Inver Grove Heights Environmental Commission
Thursday, November 14, 2024 at 7:00 PM
8150 Barbara Avenue, Inver Grove Heights, MN 55077

**Item 5.A, Attachment 1 - Pine Bend Landfill
Application (revised July 2024)**

2022 MAJOR PERMIT MODIFICATION
INVER GROVE HEIGHTS, MINNESOTA
Existing Gas Piping Plan - North Half

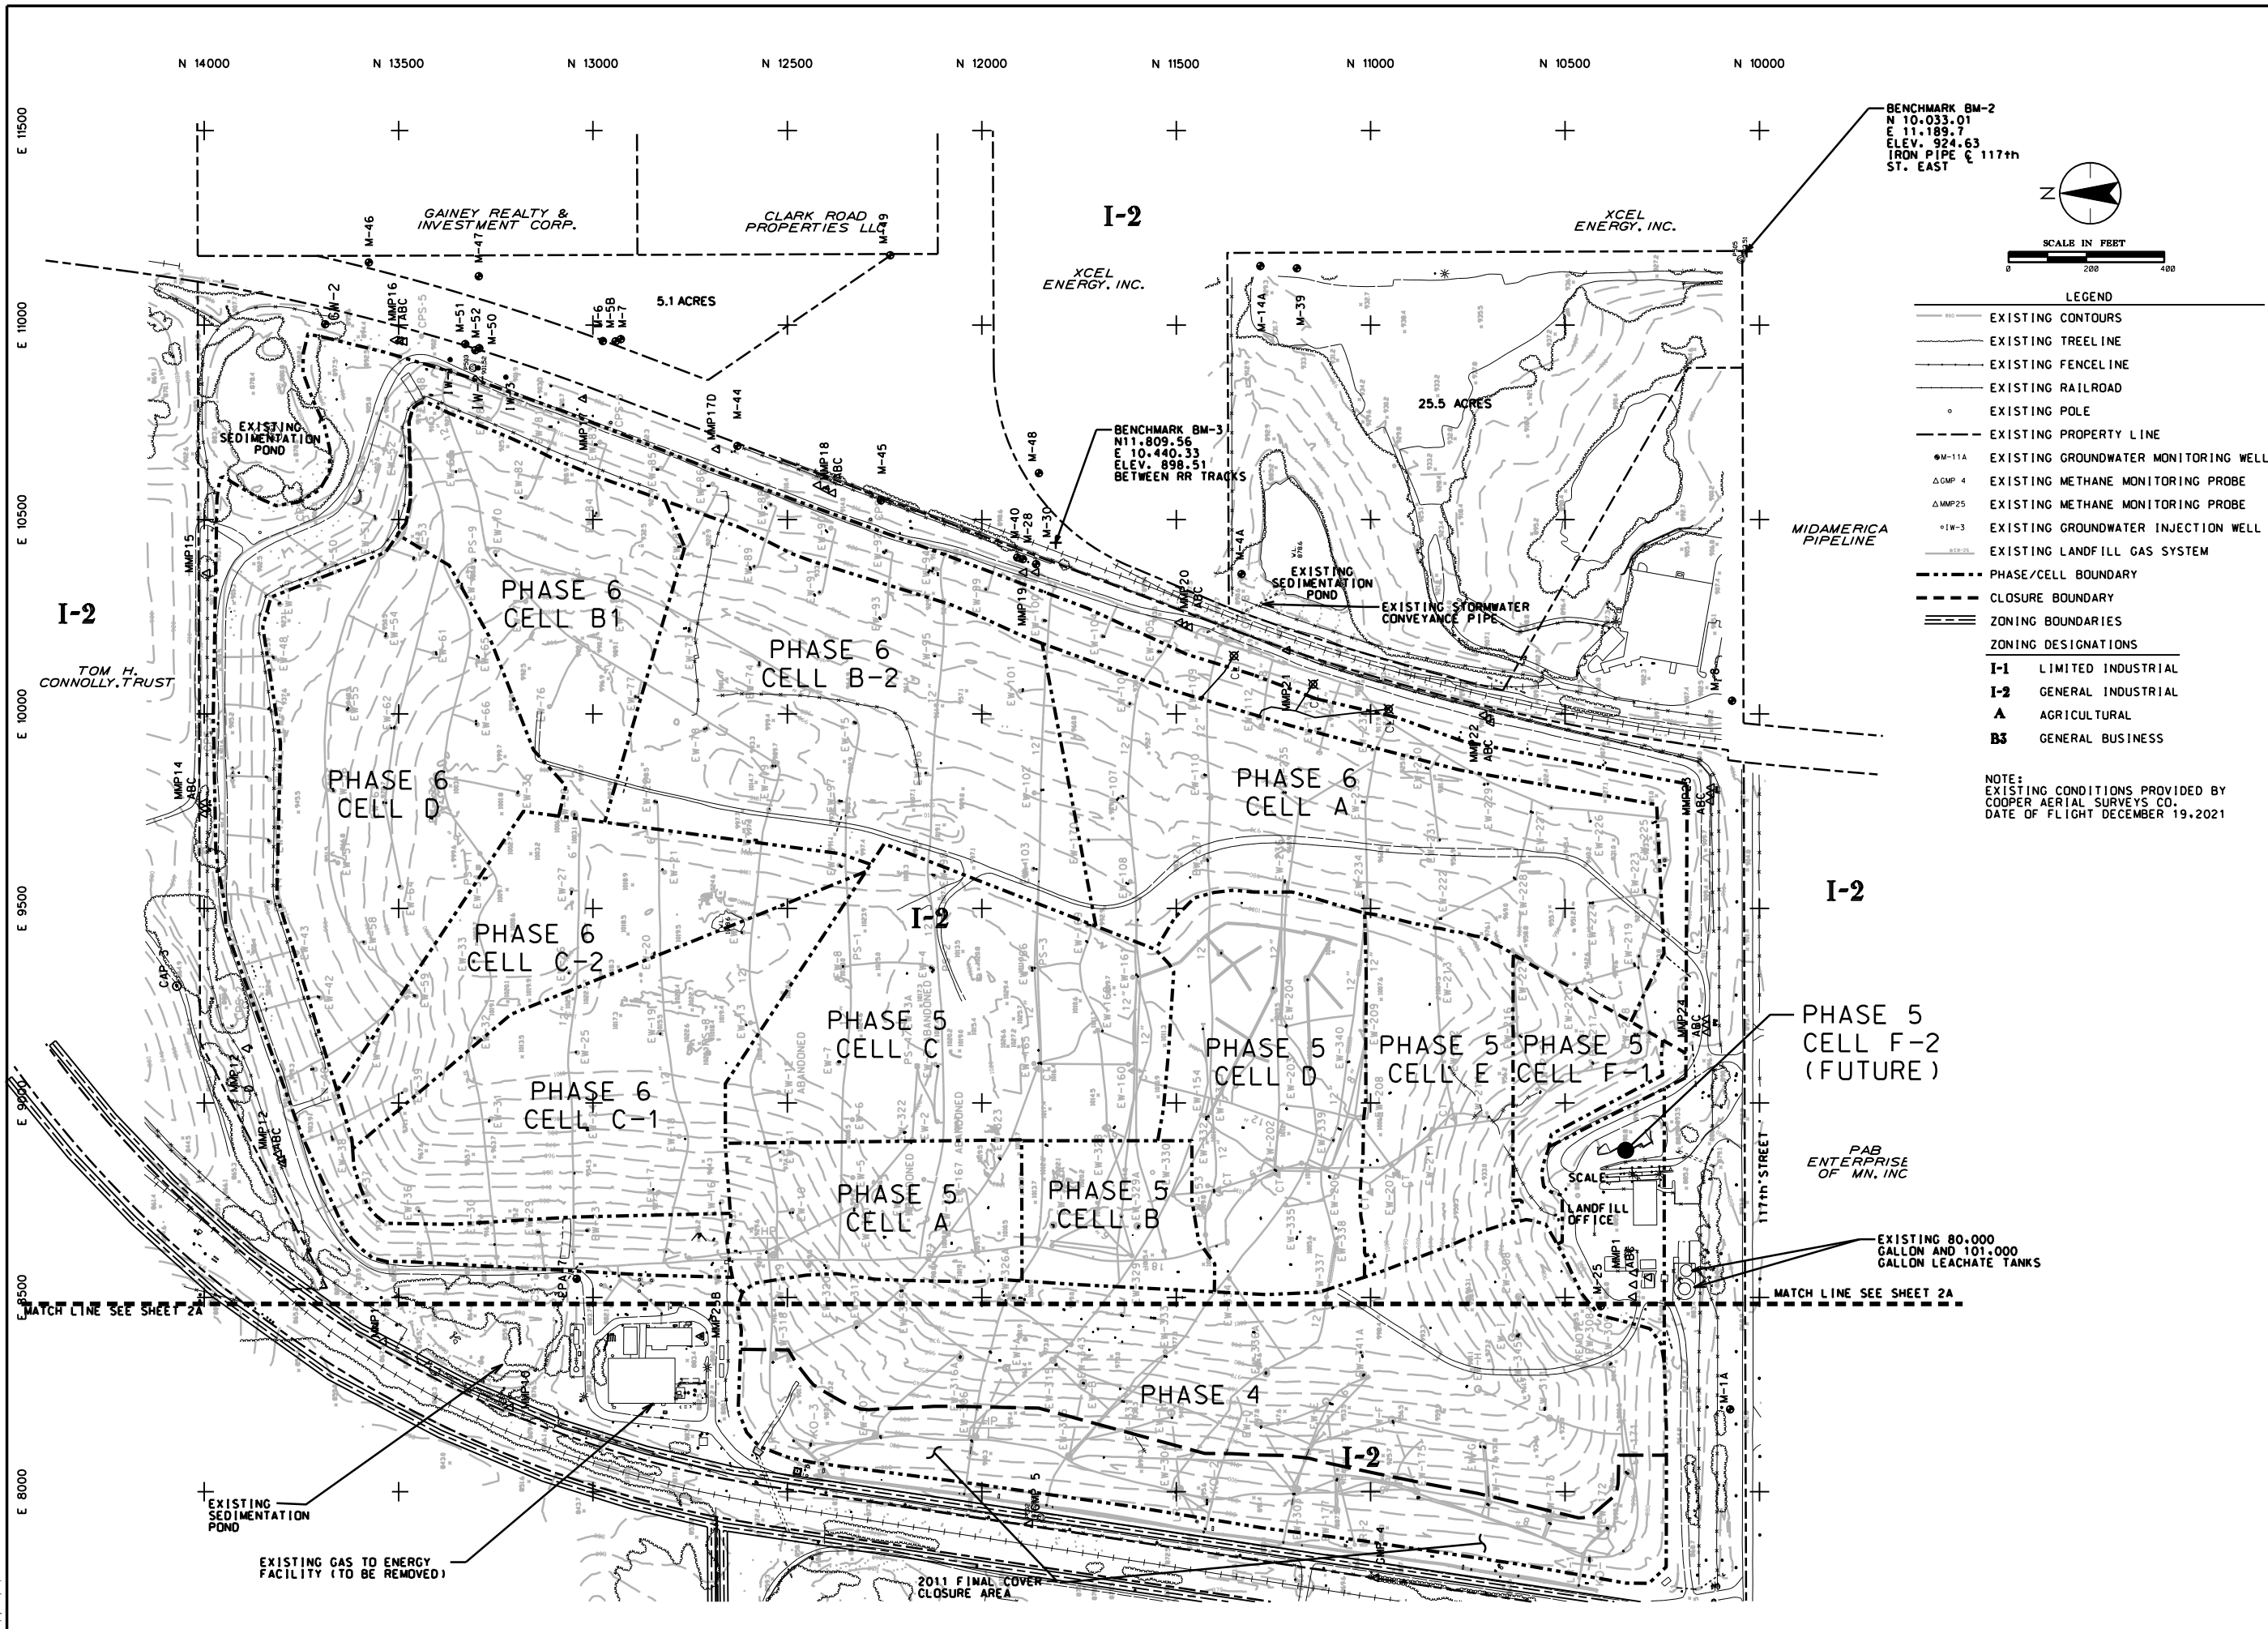
17. *Drawing 2 shows some of the Phase 6 Cells as future cells. Please update.*

Drawing No. 8
Revision Sheet

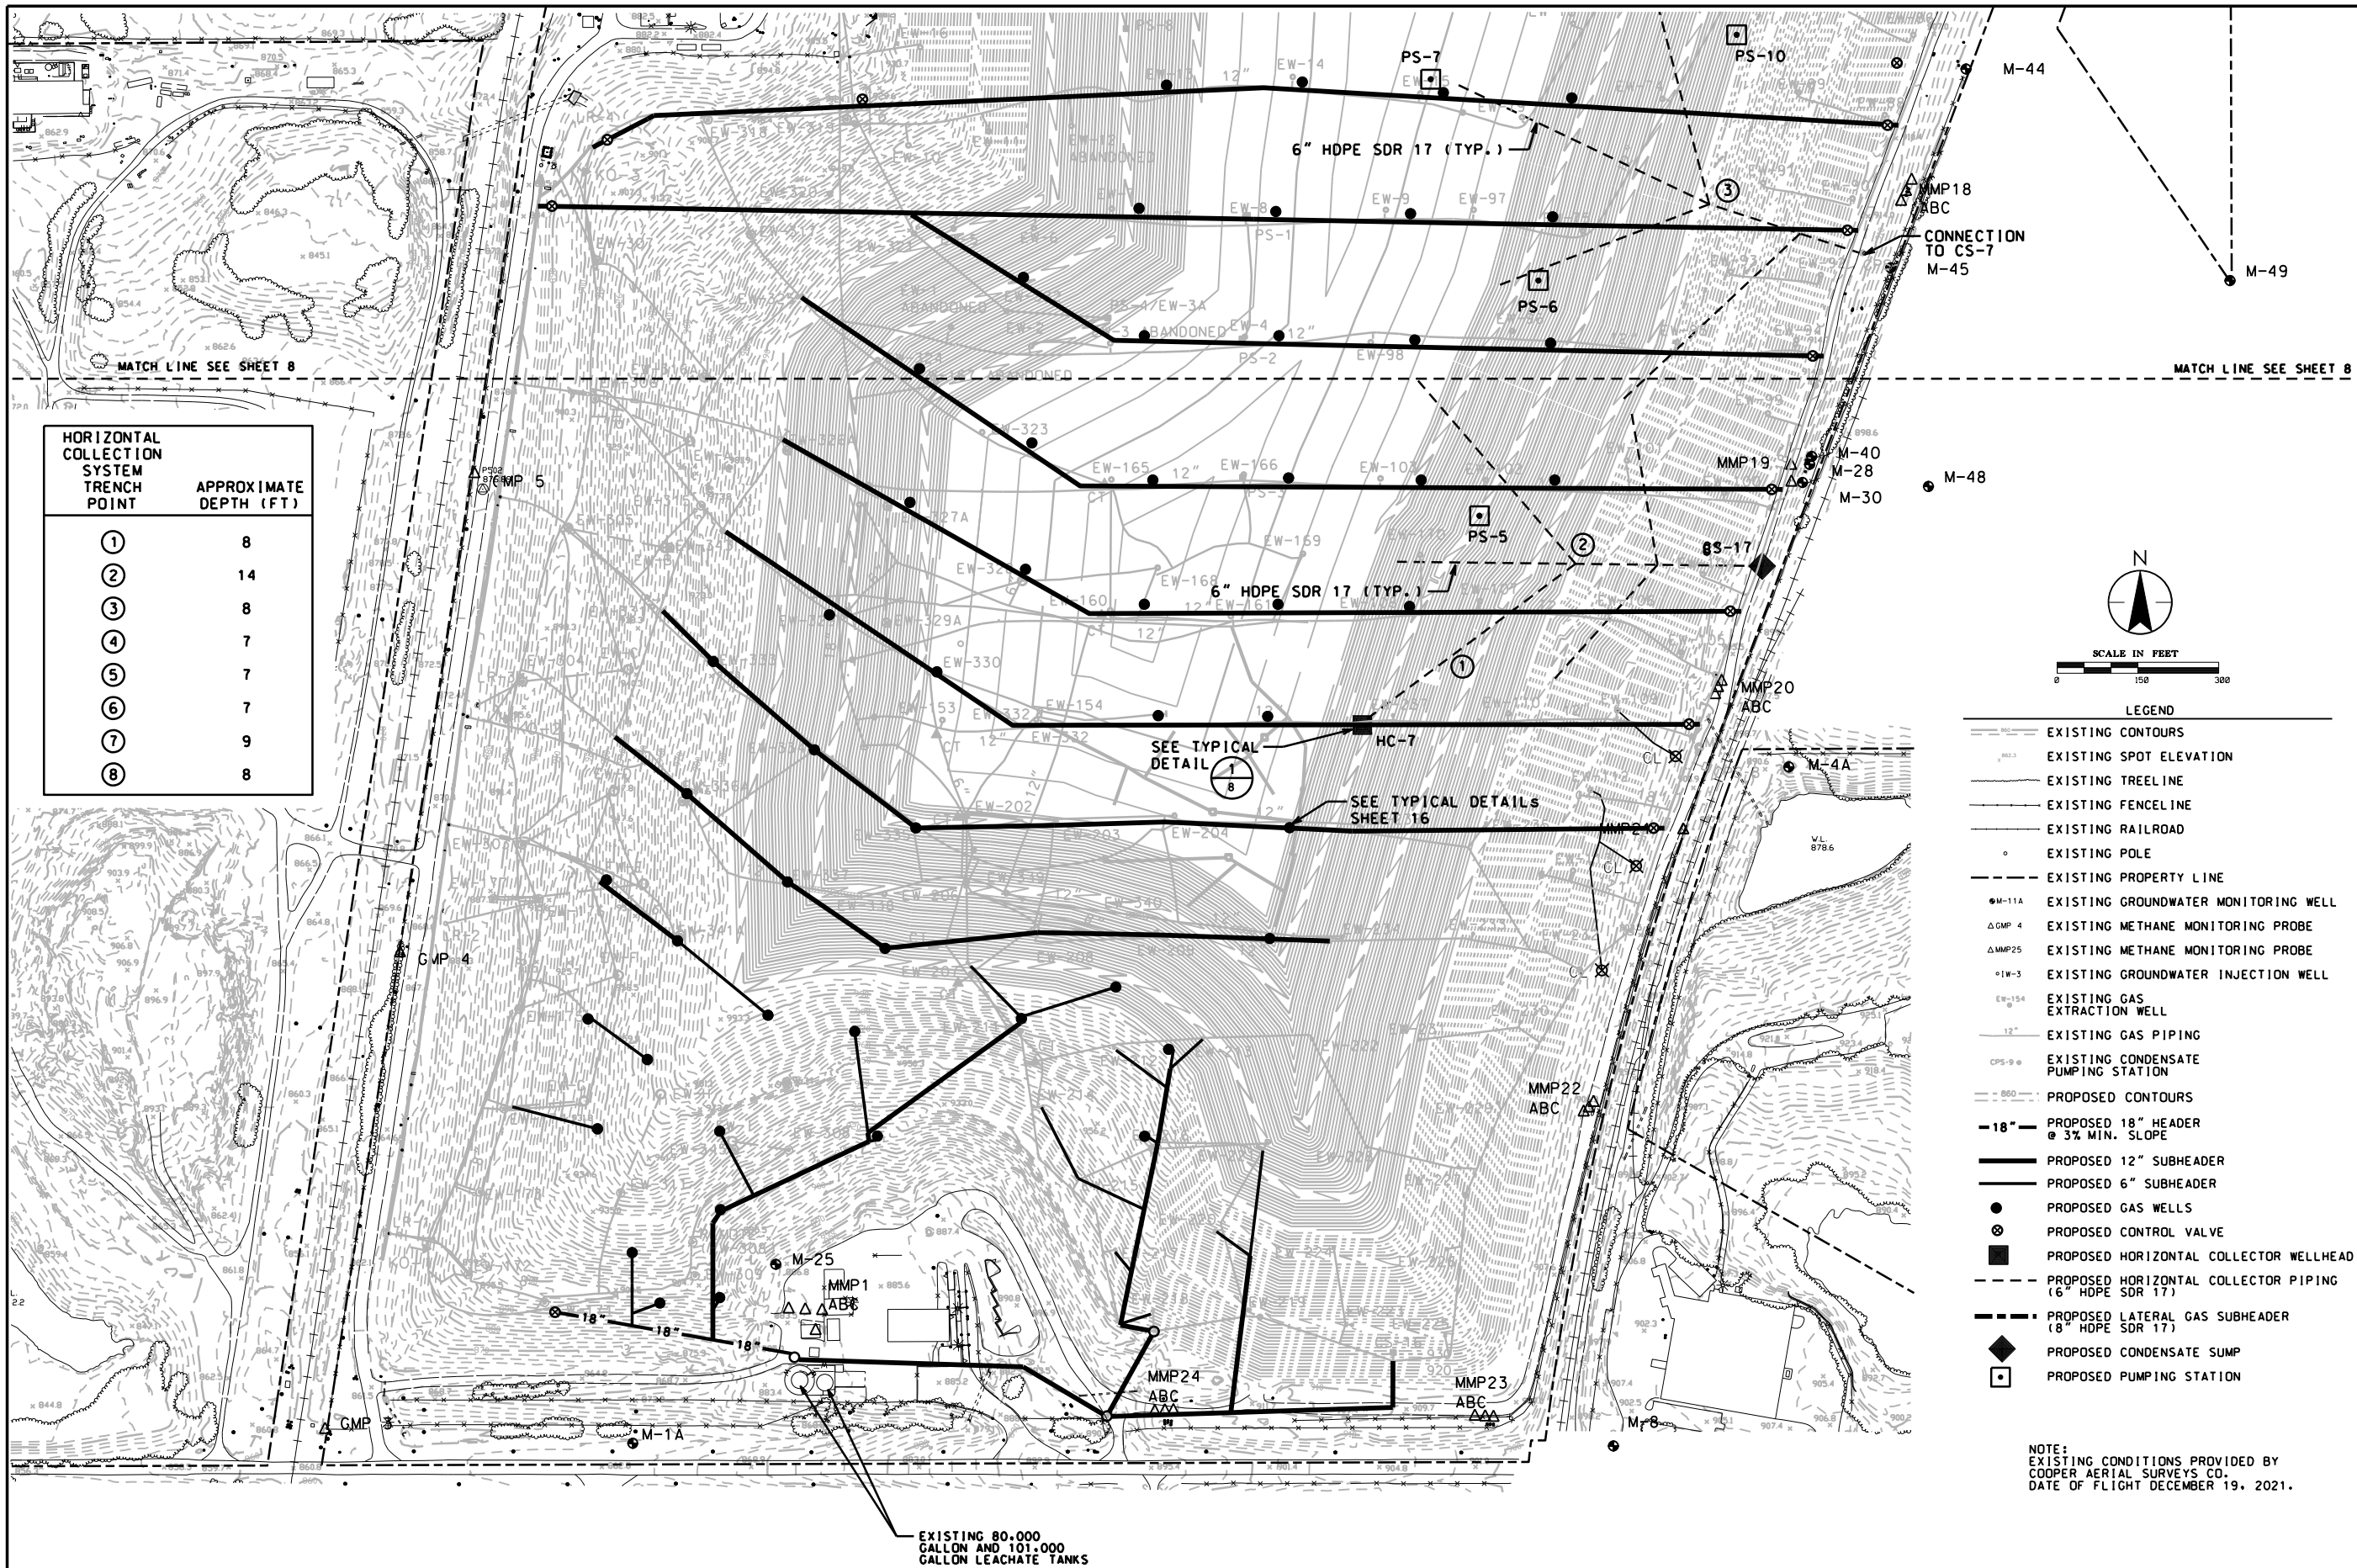
2. *Design Report, Section 4.7.4.2 describes the horizontal gas collectors installed in the Phase 6 expansion area. However, no discussion is included about any horizontal gas collectors as part of the Phase 7 expansion although Plan Drawings 8 and 9 seem to indicate that horizontal collectors will be installed as part of Phase 7. Please address this apparent discrepancy.*
